## Passenger Car Pads: 2396001 / 2396081

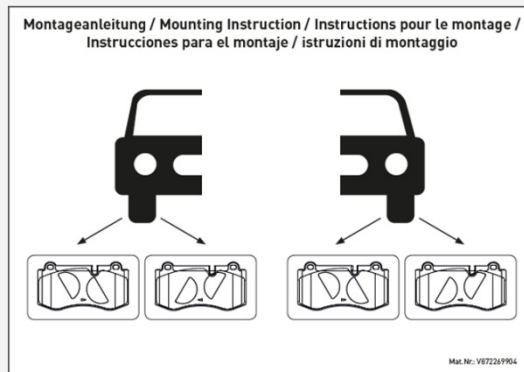
We will change the specification of 2396001 and 2396081. The full cover shim will be changed to a version with cut outs (see pictures). For the new shims it is absolutely necessary to pay attention to the correct mounting side, which are indicated by small arrows in the shim. For further explanations see below mounting instruction that is also put inside the box:

With this change we are in line with the current OES designs where this change was also done in the near past due to some noise critical applications (especially MB S-Class W221).
